**[Docket No. FAA-2018-0188; Product Identifier 2018-CE-002-AD; Amendment 39-19285; AD 2018-10-10]**

**Airworthiness Directives; Diamond Aircraft Industries GmbH Airplanes**

**ACTION:** Final rule; request for comments

Figure 1 to paragraph (g)(3) of this AD:  
Sequence of Actions for Exhaust Clamp Installation Identified in  
DAI Work Instruction WI-MSB 42-120, Revision 3, dated July 6, 2017, and  
Revision 4, dated December 20, 2017

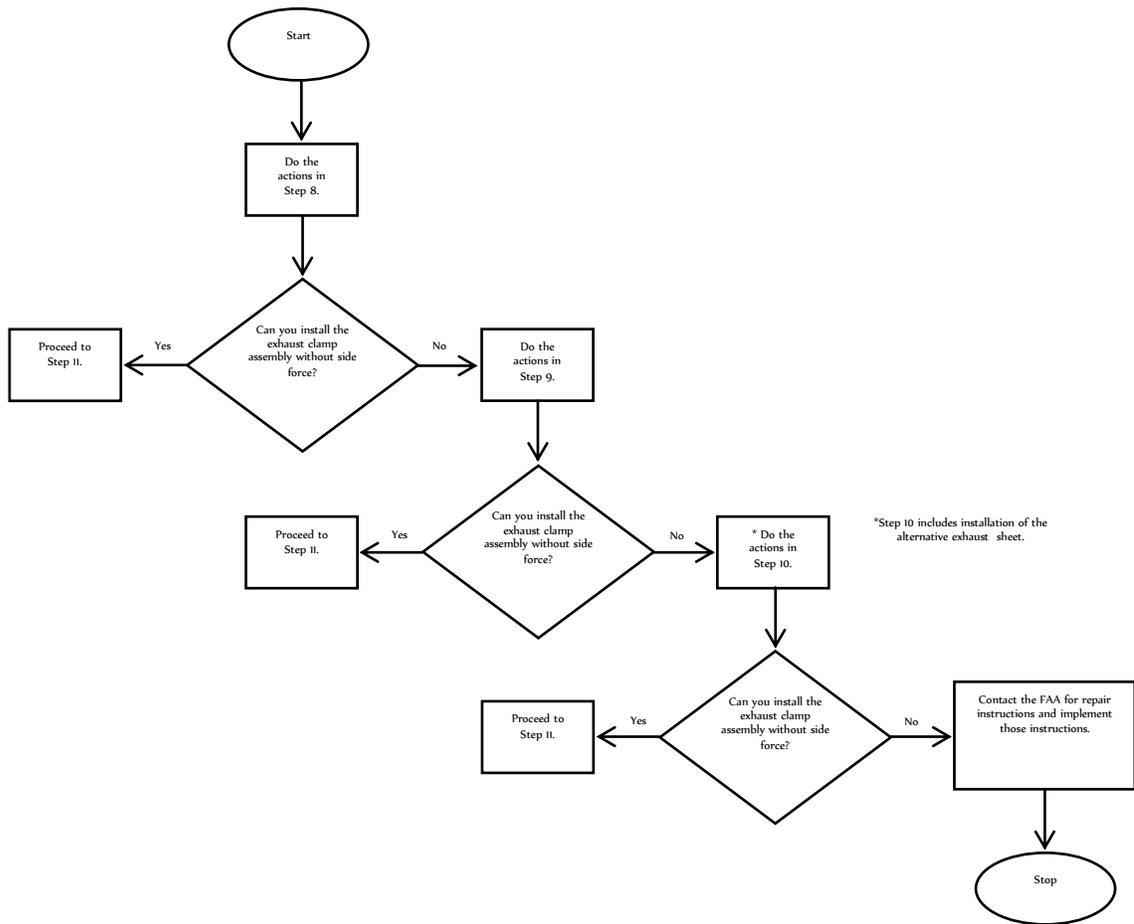
(3) Before further flight after the initial inspection required in paragraph (g)(1) of this AD and if no cracks were found or a repair to the exhaust pipe heat shield was done as required in paragraph (g)(2)(i) of this AD, then install additional engine exhaust pipe clamps, DAI P/Ns D60-7806-00-01 and D60-7806-00-02, and exhaust sheet, P/N D60-7806-00-03, and incorporate spring washers. Do the installations following III.2 Action 2 – installation of additional exhaust clamp in the INSTRUCTIONS section of DAI Work Instruction WI-MSB 42-120, Revision 3, dated July 6, 2017, or Revision 4,

dated December 20, 2017. See figure 1 to paragraph (g)(3) of this AD for additional information on the sequence of installation actions as identified in DAI Work Instruction WI-MSB 42-120, Revision 3, dated July 6, 2017 and Revision 4, dated December 20, 2017.

Figure 2 to paragraph (h)(7) of this AD:  
 Sequence of Actions for Exhaust Clamp Installation Identified in  
 DAI Work Instruction WI-MSB 42-120, Revision 3, dated July 6, 2017, and  
 Revision 4, dated December 20, 2017

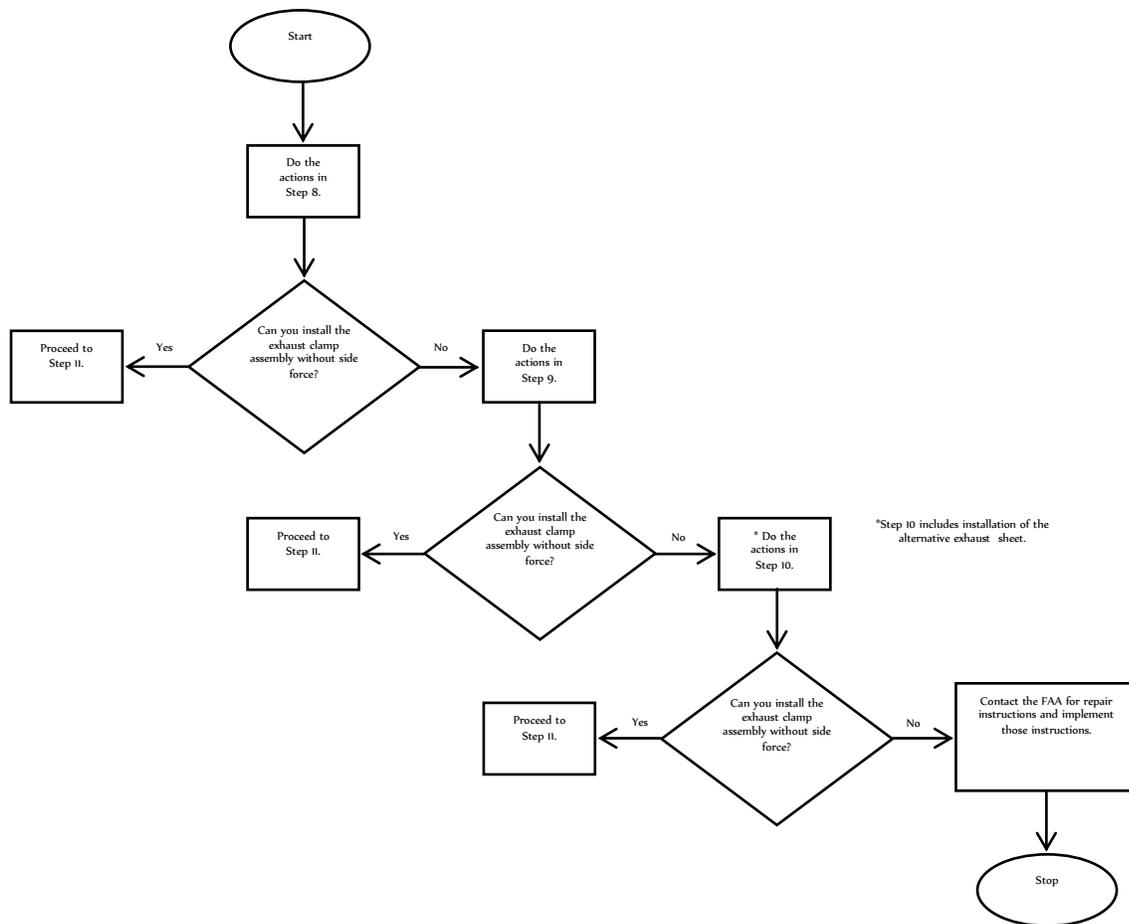
(7) Before further flight after any inspection required in paragraph (h)(6) of this AD and no crack is found, reinstall the engine exhaust pipe clamp and incorporate spring washers following III.2 Action 2 – installation of additional exhaust clamp in the INSTRUCTIONS section of DAI Work Instruction WI-MSB 42-120, Revision 3, dated July 6, 2017, or Revision 4, dated December 20, 2017. See figure 2 to paragraph (g)(7) of this AD for additional information on the sequence of installation actions as identified in DAI Work Instruction WI-MSB 42-120, Revision 3, dated July 6, 2017, and or Revision 4, dated December 20, 2017. Continue with the 25-hour TIS repetitive inspection as long as no cracks are found.

Appendix 1 to AD 2018-10-10

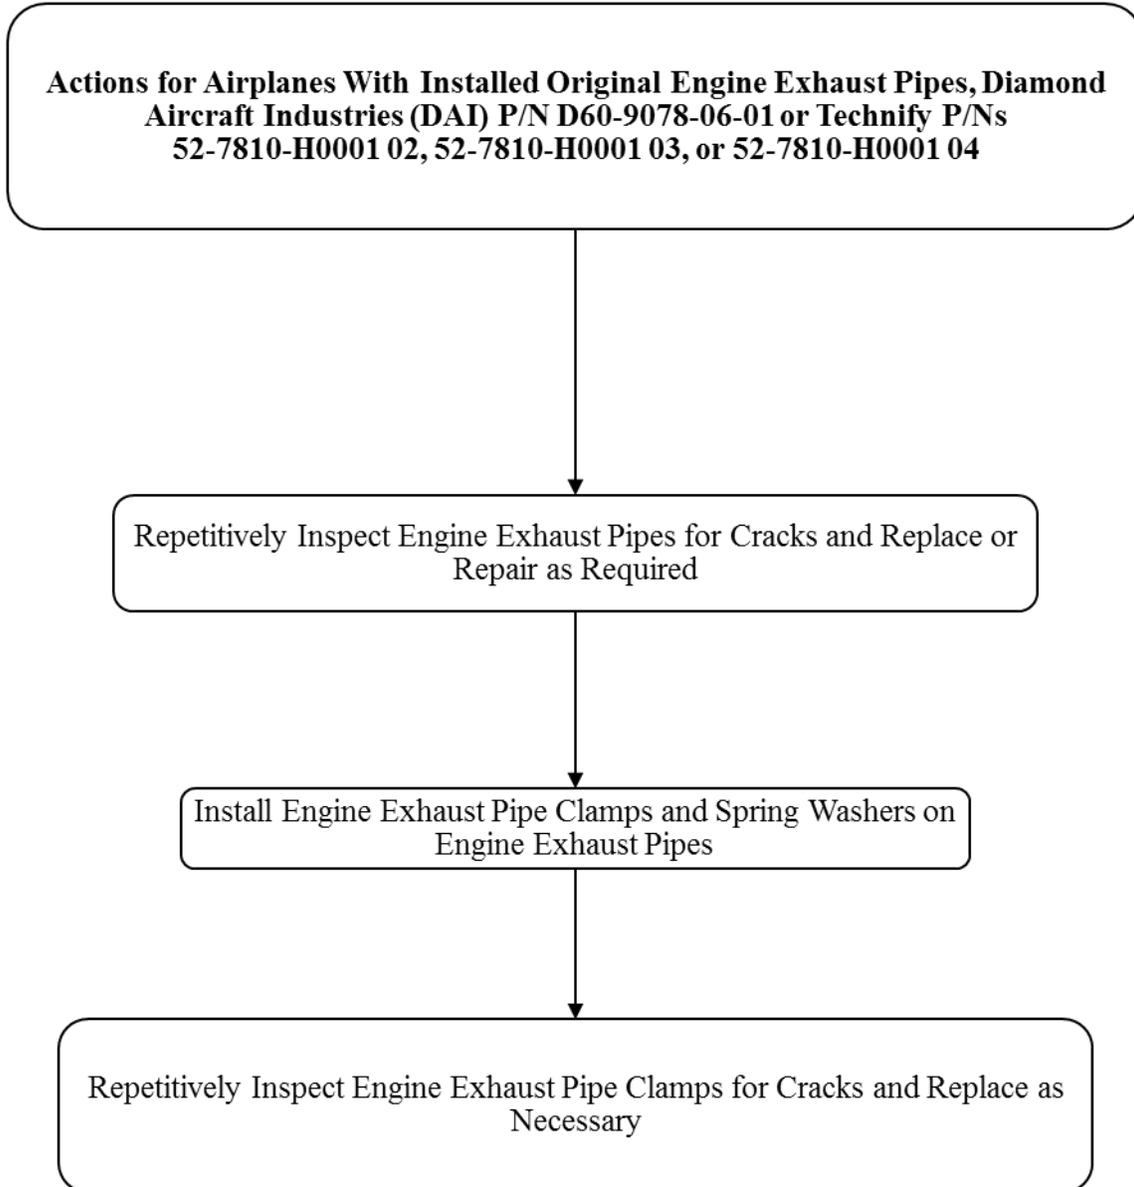
See Appendix 1 to AD 2018-10-10 for a chart of required actions. An original engine exhaust pipe is defined in paragraph (c), Applicability, of this AD.

Appendix 2 to AD 2018-10-10

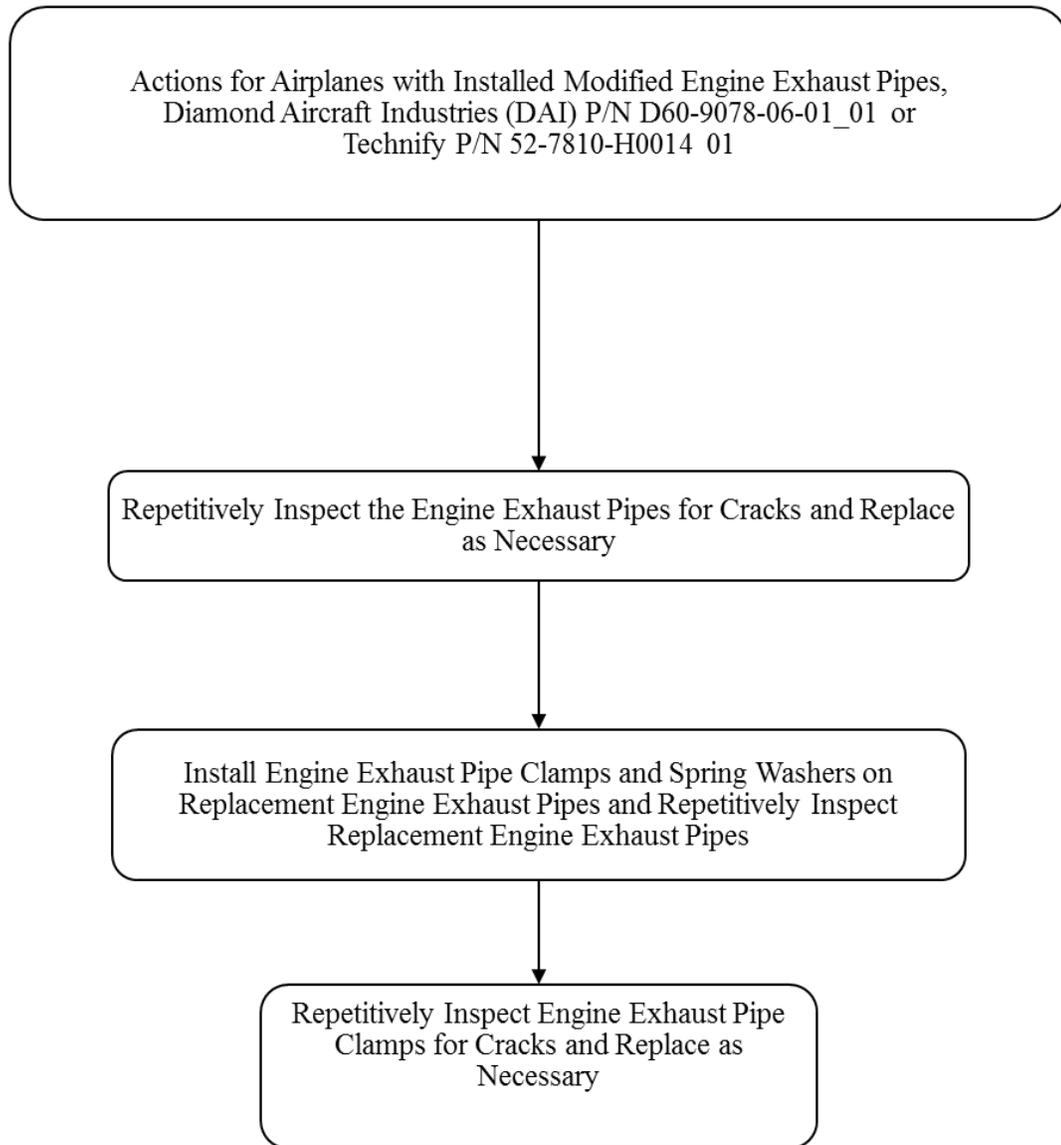
See Appendix 2 to AD 2018-10-10 for a chart of required actions. A modified engine exhaust pipe is defined in paragraph (c), Applicability, of this AD.
